# Work Order ID 95499

Item Name: Crosstube Fwd High

**D212-664-141/-141B  
ASSEMBLY DETAIL**

DRAWING NO. D212-664-141	TITLE XTUBE ASSY (205/212/412 HI FWD)	REV. D	DART AEROSPACE LTD ENGINEERING ORDER		D.E.O. NO. D212-664-141-D-1	SHEET NO. SHEET 1 OF 2	SCALE NTS
DRAWN	CHECKED	MFG. APPR.	APPROVED	DE APPR.			
DATE 11.04.07	DATE 11.04.11	DATE 11.04.12	DATE 11/04/12	DATE 11.04.12

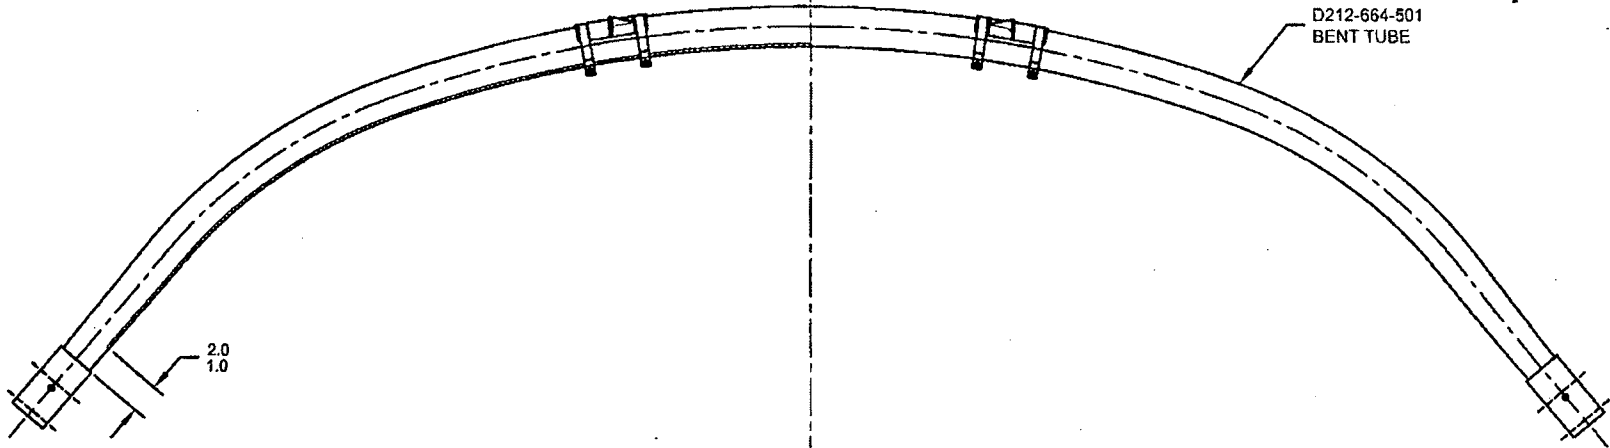
ADD AN INSPECTION WINDOW TO UNDERSIDE OF CROSSTUBE.

IS:

WAS:

- 2) FINISH: CHEMICAL CONVERSION COAT PER DART QSI 005 4.1  
PRIME INSIDE AND OUTSIDE PER DART QSI 005 4.2  
MASK UNDERSIDE OF CROSSTUBE AS SHOWN (HATCHED AREA) AND  
PAINT OUTSIDE PER DART QSI 005 4.2  
REMOVE MASKING AND APPLY CLEAR COAT

MASK AREA PRIOR TO PAINTING,  
REMOVE MASKING AFTER PAINT  
AND APPLY CLEAR COAT
